HISTORIC AND DESIGN REVIEW COMMISSION

September 20, 2017

HDRC CASE NO: 2017-473
ADDRESS: 228 SHERMAN ST
LEGAL DESCRIPTION: NCB 512 BLK 25 LOT W 58.33 FT OF E 116.66 FT OF N 48.7 FT OF 11
ZONING: R-4, H
CITY COUNCIL DIST.: 2
DISTRICT: Dignowity Hill Historic District
APPLICANT: Jarrad Campos
OWNER: Ricardo Gomez
TYPE OF WORK: Rear addition, exterior modifications
REQUEST:

The applicant is requesting a Certificate of Appropriateness to:

SIDE ELEVATION

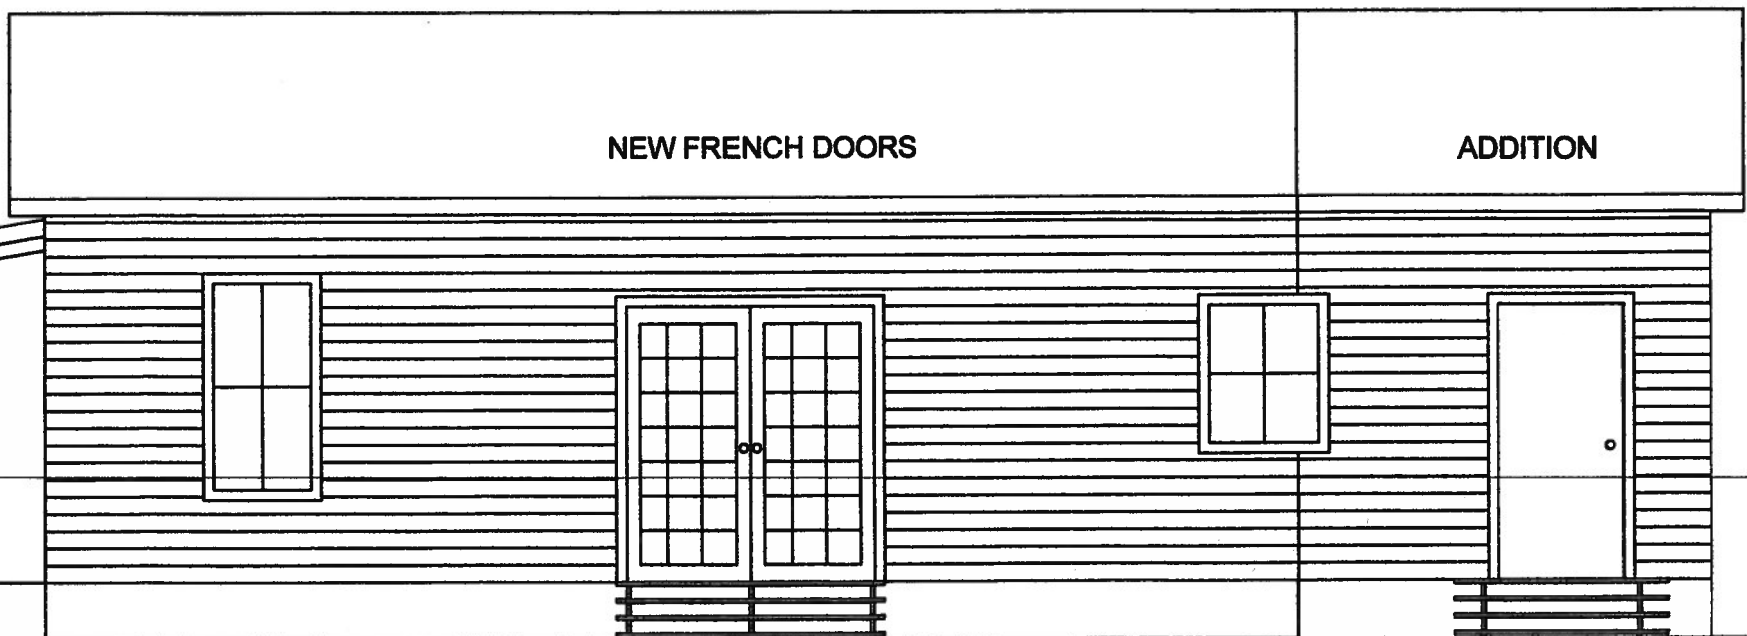
- f. **DOOR INSTALLATION** – The applicant has noted the installation of two French doors on the side elevation as well as a new door in the addition. Staff finds the proposed door to the addition to be appropriate; however, the applicant should propose to install a door that is consistent with the Guidelines and feature materials that are complementary with those found historically in the district. Regarding the installation of French doors, the Guidelines for Exterior Maintenance and Alterations 6.A.i. notes that new entrances should not be created on primary facades or where visible from the public right of way. Staff finds that the installation of a door at this location may be appropriate; however, the door should be profiles to be consistent with the existing, historic door openings. French doors would not be appropriate.

- v. That a single width door be installed in place of the proposed French door.
- vi. That the existing concrete porch should remain visible. The proposed panels should be 18 to 21 inches in width, seams should be 1 to 2 inches in height a crimped ridge seam should be used where flashing occurs and a standard galvalume finish should be used.
